RESPONSE TO COMMENTS (part 1) on 2002-2004 STATE OF NEW MEXICO §303(d) LIST FOR ASSESSED SURFACE WATERS:

COMMENT SET A --

Surface Water Quality Bureau (SWQB) Staff Comments -- The following changes were made to the database and 303(d) list and/or Record of Decision (ROD) as a result of additional SWQB and EPA Region 6 staff review:

Rio Hondo (Rio Grande to US Forest Service boundary)

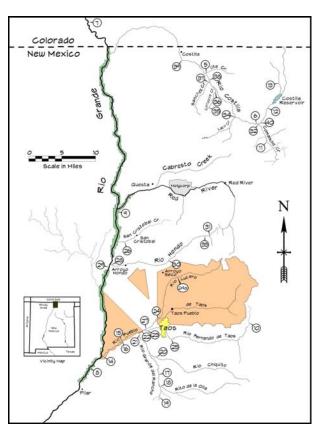
COMMENT: - What is the water quality in the Rio Hondo?

*RESPONSE: The Rio Hondo was intensively sampled in 1975, 1979, 1980, 1981,1992, and 2000 by the Surface Water Quality Bureau (NMED SWQB/EID 1981, 1992, 2002 in draft). A 1992 water quality survey (Feb.-December) showed very few exceedances (10) of the New Mexico Water Quality Standards. One exceedance for total inorganic nitrogen was observed directly below the Twining WWTP in February while the remainder of the exceedances were observed in Valdez and Arroyo Hondo (temperature, nutrients and unionized ammonia) and were probably caused by the rivers proximity to the communities of Valdez and Arroyo Hondo, and specifically to perturbations associated with livestock grazing, irrigation return flow, septic tank leach fields and other agricultural activities (Jacobi et al 1998). Exceedances of the un-ionized ammonia standard at the site above the Rio Grande can be attributed to a lack of canopy vegetation along the riparian strip, in turn contributing to increased primary productivity, elevated temperatures and pH (Jacobi et al 1998). An associated intensive benthic macroinvertebrate study in 1992 noted that the Twining WWTP had a localized effect on the biological condition of the upper Rio Hondo. According to the study, the influence to the biological condition was minimal as the flow left the Carson National Forest (Jacobi et al 1998).

This assessment unit was not included on the 2000-2002 §303(d) list.

One value for pH (8.92) was outside the allowable range (6.6-8.8) on 19 October out of eight samples collected at Station 28. However, the proportion of exceedences was such that this assessment unit is in full support of the pH standard, but impacts have been observed that warrant close attention during future surveys.

The temperature criterion (20°C) was exceeded twice (21.7°C on 31 July; 21.9°C on 01 August) out of eight samples collected at Station 28. Thus, this assessment unit is in partial support for temperature.

Rio Fernando de Taos (Rio Pueblo de Taos to headwaters)

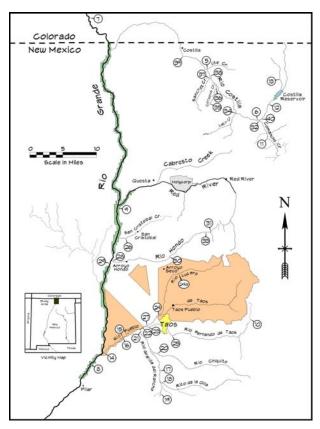
I read in the Taos News that you are seeking input from the public regarding the impaired waters in Taos. I would like to comment on the Rio Don Fernando de Taos.

I would like to call your attention to the pending septic variance that was recently granted by the NMED to the developers of the condominium complex so that they will be able to build 18 new units. Their proposed system, the Nayadic system, is a high-maintenance system that the developers plan to install, then leave to the homeowners to maintain. We are not a rich association. We have no maintenance staff and provide no services other than garbage collection and electricity for our drinking water wells. The developers' record from their previous work is less than reassuring. Our four-year-old road is crumbling, our current septic system was installed without markers to enable us to clean them and their permit application for the current system undercounted the number of existing bedrooms in the complex.

Given that situation, I think it is all the more imperative that the NMED do everything in its power to limit further pollution into this river. The only purpose for the variance is to allow the developers to build more vacation homes and make more money than they would otherwise be able. Do we really want to further pollute our precious resources just to enrich them?

*RESPONSE: Thank you for bringing our attention to this matter. We received similar comment via phone from Francis Chandler who also lives in your community. Three stations on the Rio Hondo were surveyed as part of the Upper Rio Grande 1 intensive water quality survey in 2000. The results of this latest survey are reflected in the 2002-2004 Clean Water Act 303(d) list. The following information is a section from the draft report summarizing the results (NMED SWQB 2002 in draft):
